|  | GROUP<br>ENG  | MODEL<br>2014~2015MY<br>Cadenza (VG) |
|                                                                                   | NUMBER<br>148 | DATE<br>September 2015               |
| <p align="center"><b>TECHNICAL SERVICE BULLETIN</b></p>                           |               |                                      |
| <p><b>SUBJECT: CHATTER/RATTLE NOISE FROM ENGINE AFTER COLD SOAK</b></p>           |               |                                      |

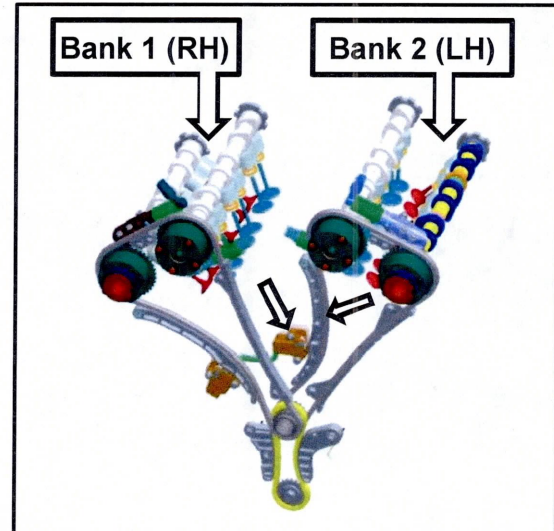
This Service procedure should ONLY be performed on engine bank 2 (LH), as shown.

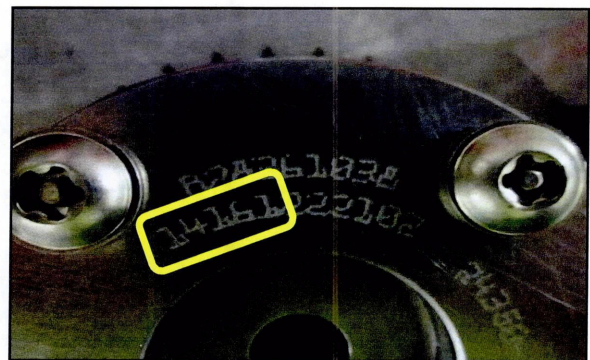
1. Refer to the “Engine Mechanical System → Timing System → Timing Chain” section in the applicable Workshop Manual on KGIS, to install the improved parts. **NOTE: prior to installation, refer to steps 2~4 for supplementary inspection/installation information.**
2. After removal of timing chain cover, inspect CVVT’s on both engine banks to ensure the first five (5) digits of the eleven (11) digit serial number is equal or greater than “14111”, on both Intake and Exhaust CVVTs. If the serial number is greater than 14111, proceed to step 4. If the serial number is less than “14111”, replace the CVVT(s) prior to performing the remainder of this TSB procedure.

Additionally, inspect the replacement CVVTs to ensure the first five (5) digits of the serial number are greater than “14111”.

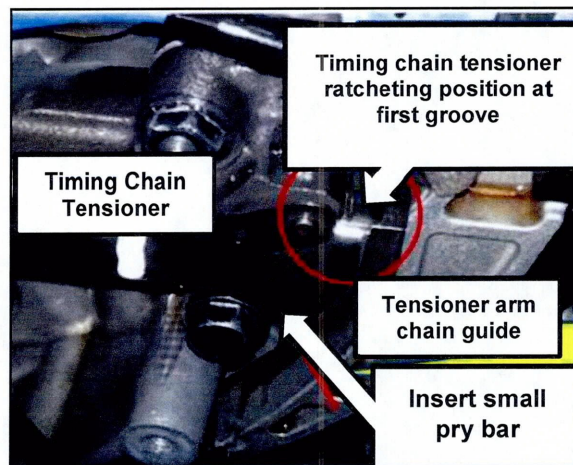
Prior to removing chain tensioners/adjusters, note position of the timing chain tensioner pawl to the rack grooves and count the number of teeth/grooves extending from the tensioner, as shown below. Make sure to record the count for later reference.

3. After installing the new tensioner, and timing chain guide, manually rotate the crankshaft three (3) full revolutions to securely seat the tensioner, then, check the number of grooves extending from the tensioner. When compared to the initial count, it should now be one (1) groove further out towards timing chain.

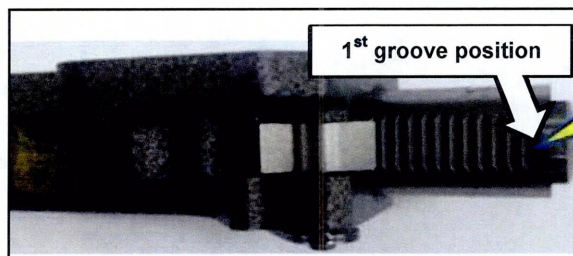
4. If after tensioner and guide replacement the tensioner pawl rack is not extended one tooth/groove further out than before the repair, use a small pry bar to extend the tensioner out one (1) tooth/groove further towards timing chain, as shown.

Do **NOT** extend the tensioner pawl rack out more than one tooth/groove or damage to timing chain may occur.
